Access Compliance Report

Public Rights-of-Way (Curb Ramps)

Intersection ID: 51212	Main Street: PROVIDENCE_ROW_LN	Cross Street: ARDREY_KELL_RD	Location: NE
ADA ID: 7F5F4FF60253	Ramp Type: Perp	Initial Pass/Fail: Fail	Overall Compliance: No Severity Score: 13.75

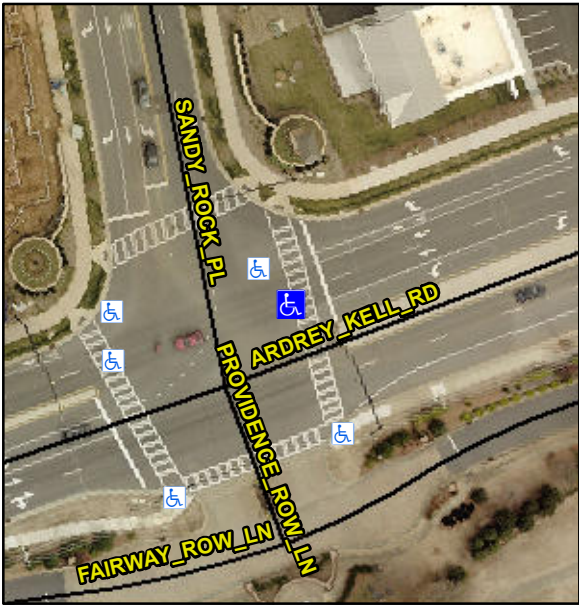
Codes/Mitigation Info/Possible Solution			Field Measurements/Component Compliance					
	Possible Solutions:		Compliance	Description	Data	Compliance	Description	Data
	Remove & Replace Entire Ramp.		N/A	Ramp Length (in)	96.0	No	Ramp Slope (%)	8.9
			Yes	Ramp Width (in)	60.0	No	Ramp XSlope (%)	3.0
			N/A	Flare Type LT	N/A	N/A	Flare Type RT	N/A
			N/A	Flare Slope LT (%)	N/A	N/A	Flare Slope RT (%)	N/A
			N/A	Flare Traversable LT?	N/A	N/A	Flare Traversable RT?	N/A
			N/A	Landing Length (in)	N/A	N/A	DWS Provided?	N/A
			N/A	Landing Width (in)	N/A	N/A	DWS Contrast?	N/A
			N/A	Landing Slope (%)	N/A	N/A	DWS Length (in)	N/A
			N/A	Landing X Slope (%)	N/A	N/A	DWS Full Width?	N/A
Surveyor Notes:			N/A	Landing Curb? (Y/N)	N/A	N/A	DWS Offset (in)	N/A
PROW/ADA:				Shared Landing?	N/A			
R304.2.2, R304.5.3				Gutter Ponding?	N/A	N/A	Gutter Slope (%)	N/A
				Gutter Lip Ht (in)	N/A	N/A	Gutter X Slope (%)	N/A
				Painted X Walk1?	Yes	N/A	Painted X Walk2?	N/A

X Walk 1 Direction	To S		X Walk 2 Direction	N/A
				X Walk 1 Width (in)	112.0	N/A	X Walk 2 Width (in)	N/A
				X Walk 1 Slope (%)	0.9		X Walk 2 Slope (%)	N/A
				X Walk 1 X Slope (%)	2.3		X Walk 2 X Slope (%)	N/A
				Ramp inside XWalk1?	Yes	N/A	Ramp inside XWalk2?	N/A
				Road Slope (%)	N/A	N/A	Clear Space?	N/A
				Road X Slope (%)	N/A	N/A	Clear Space to XWalk (in)	N/A
				Any Obstructions?	N/A	N/A	Storm Grate/Utility Hazard?	N/A
				Obstruction Type			Storm Grate/Utility Type	
					N/A			N/A
						Yes	Surface Condition? (G/P)	Good
Total Cost:		\$ 1850.00
